# **CHRISTCHURCH DISTRICT PLAN**

## **PLAN CHANGE 14**

### **HOUSING AND BUSINESS CHOICE**

#### **PLANNING OFFICER'S REPORT OF HOLLY ELIZABETH GARDINER UNDER SECTION 42A OF THE RESOURCE MANAGEMENT ACT 1991**

Figure 2 Extract from planning maps showing PC14 proposed zoning for the subject site

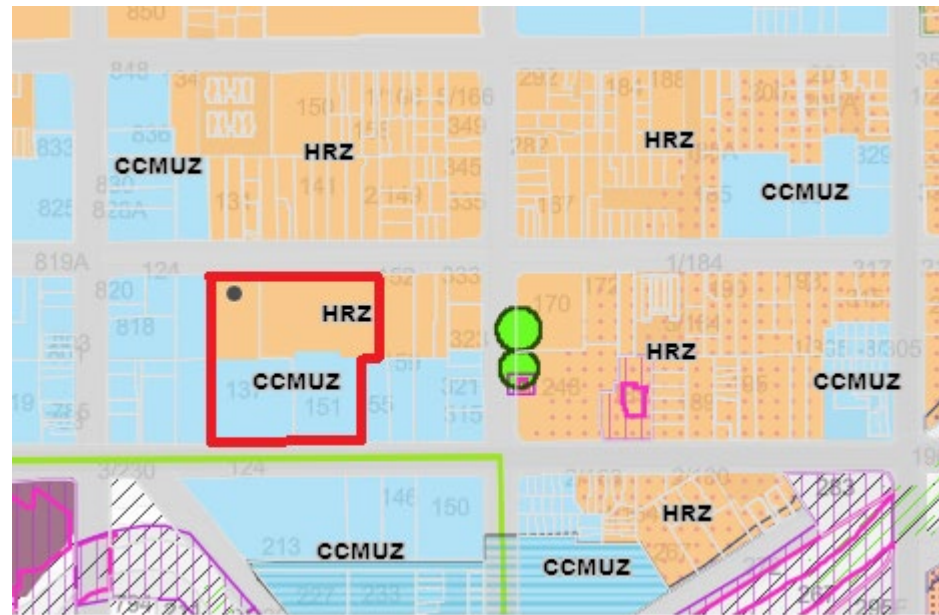
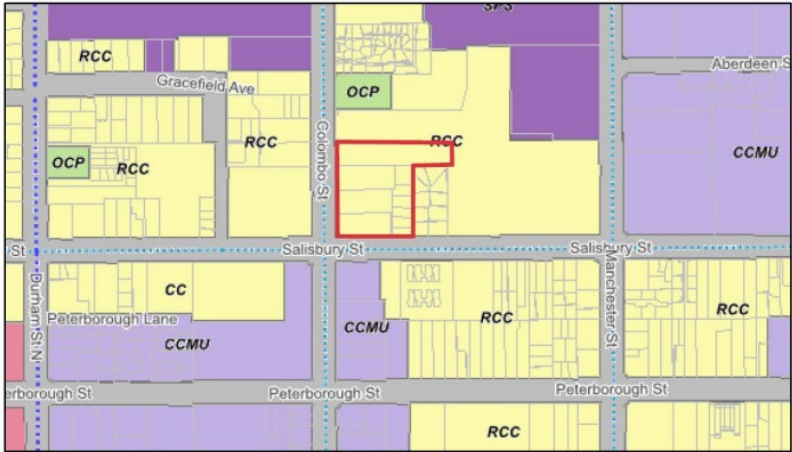
Turning to the surrounding land use and pattern of development, as shown in figure 2 below, land to the west of the site is wholly within the Central City Mixed Use Zone, and appears to be in a transitory phase of development, consisting of surface level carparking areas and some commercial activity. Remaining land in the block to the east of the subject site is also proposed to have a split zoning between High Density Residential and Central City Mixed Use. It is also in a transitory phase of development, consisting of surface level carparking on the Central City Mixed Use portion of the land; and an urban farm on the residential portion of the land. Land to the north of the subject site is zoned for, and developed for, residential purposes.

When looking at the wider zoning context and land use in the surrounding area, the split zoning on the subject site (and adjoining land to the east) provides a transition between the areas of Central City Mixed Use land in the area and those areas zoned for residential activity. In relation to Peterborough Street, the residential zoning on this part of the street reflects the residential zone to the north of the

Figure 4 Extract from planning maps showing PC14 proposed zoning for the subject site and wider area.

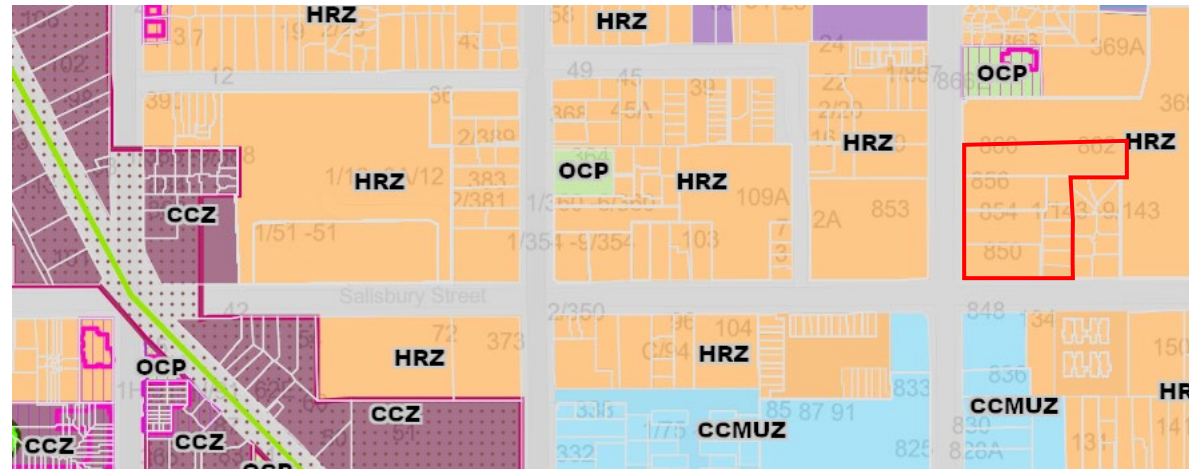
the wider area from a zoning perspective, as shown in figure 4, land on the northern side of Salisbury Street between Durham Street North and Manchester Street is all within the High Density Residential zone, forming a sleeve of residentially zoned land at the edge of the Central City Mixed Use zone. Amending the zoning of the subject site to the Central City Mixed Use zone would interrupt this zoning pattern and the land uses it is seeking to provide.

In conclusion, it is my recommendation that this submission point be rejected.

Figure 6 Extract from planning maps showing PC14 proposed zoning for the subject site and wider area.

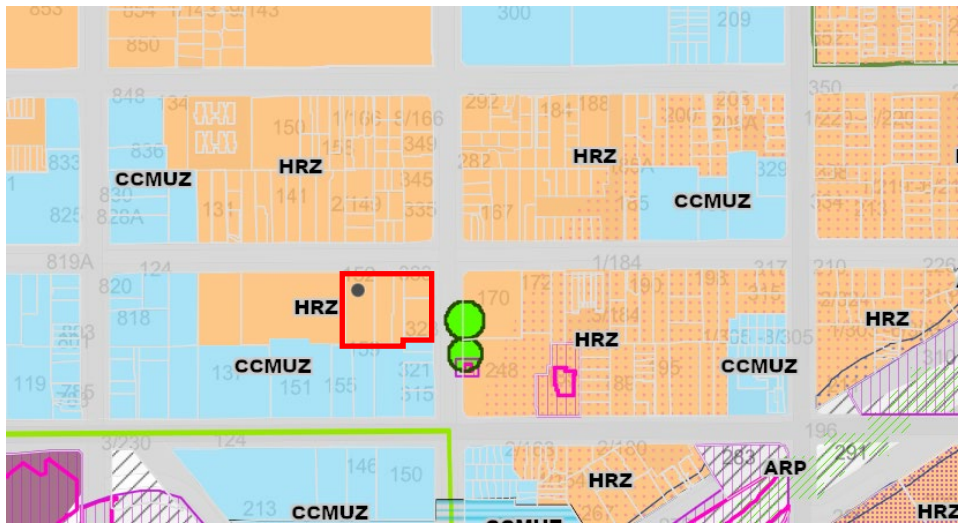
|  | <p>In assessing the merits of the rezoning request, I have considered the scope of PC14; the direction outlined in the relevant policies of the NPS-UD; and the existing use and pattern of development on the site and surrounding environment. These matters are addressed in turn below.</p> <p>It is my view that the rezoning request cannot be considered within the scope of PC14, firstly because the spatial extent of the zones within the Central City are not proposed to be changed, nor are any changes proposed to the zoning in the area of the subject site.</p> <p>In the context of the city centre zones, Policy 3 of the NPS-UD requires that <i>“building heights and density of urban form [is enabled] to realise as much development capacity as possible, to maximise benefits of intensification.”</i></p> <p>If such insufficient development capacity is provided by changing height and density provisions, then it follows that increases to building heights and densities of activity should be made via changes to these provisions (rather than changing the underlying zoning to achieve the desired development capacity levels). I do not consider that the intention of this Policy, nor the overall NPS-UD provides for wholesale changes to the zoning of commercial sites within the city centre zones unless specific circumstances exist to warrant such a change.</p> <p>Further, modelling completed by Dr Dyason and peer reviewed by Mr. Lees<sup>3</sup> outlines that, prior to the changes proposed by PC14 there was sufficient land capacity to meet demand over the next 30 years within the central city. With demand to 2051 forecasted to be 25.6ha across retail, office, industrial, warehousing, and short-stay land uses; and the total land supply being 61.5ha. I therefore consider that, with the additional building heights enabled in the CCZ there is no need for this land to be rezoned and instead indicates a surplus of 35.9ha.</p> <p>Turning to the surrounding land use and pattern of development, I concur with the submitter’s description of the surrounding land use and zoning in the immediacy of the site. However, as shown in figure 6 below, looking at the wider area from a zoning perspective, land on the northern side of Peterborough Street between Colombo Street and Cambridge Terrace is largely all within the High Density Residential zone. This area is part of a wider high density residential block between Salisbury Street, Colombo Street, Cambridge Terrace and Barbadoes Street forming at the edge of the Central City Mixed Use zone. Amending the zoning of the subject site to the Central City Mixed Use zone would interrupt this zoning pattern and the land uses it is seeking to provide.</p> <p>In conclusion, it is my recommendation that this submission point be rejected.</p> |

Figure 8 Extract from submission above showing PC14 proposed zoning for the subject site and wider area.

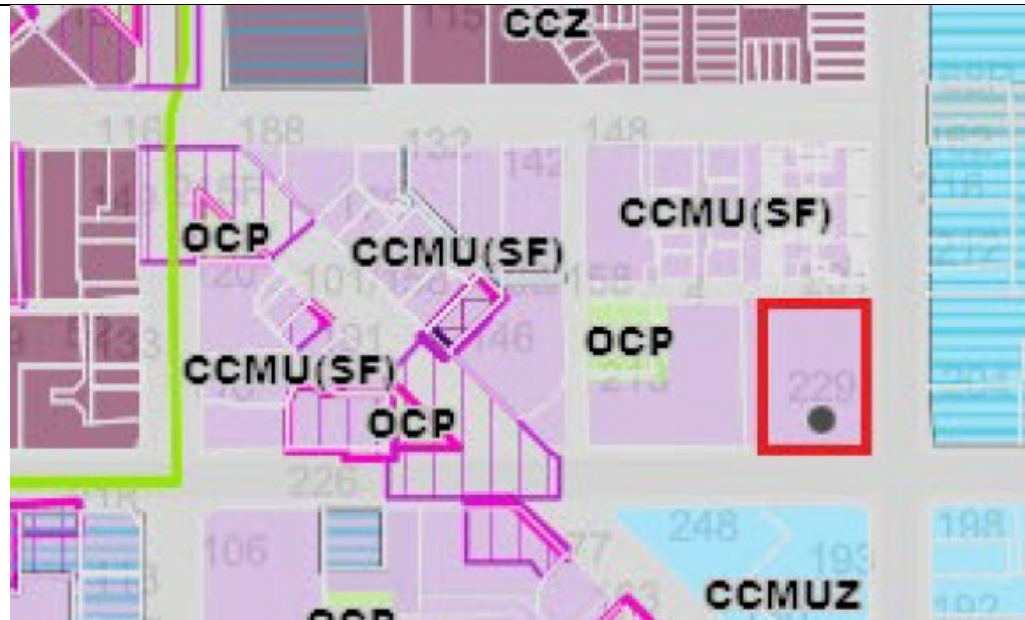
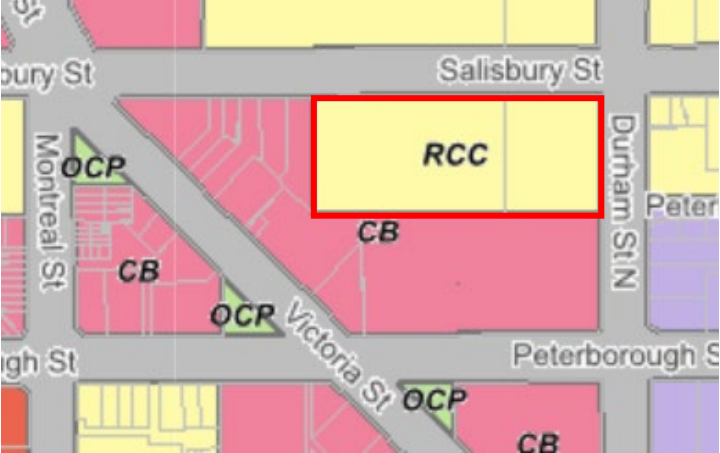
Plan Change 14 proposes that the height limits of the Central City Mixed Use Zone (South Frame) are increased from 17m to 21m. An increase of 17m to 32m is proposed within the Central City Mixed Use Zone. The submitter's preferred zoning for the block of land is to include it in the City Centre Zone. This would enable a far greater increase in height limit (up to 90m as a restricted discretionary activity, and above 90m as a discretionary activity), but would also disrupt the function of the South Frame when viewed in the wider context of the zoning in the area (figure 8).

In conclusion, it is my recommendation that this submission point be rejected.
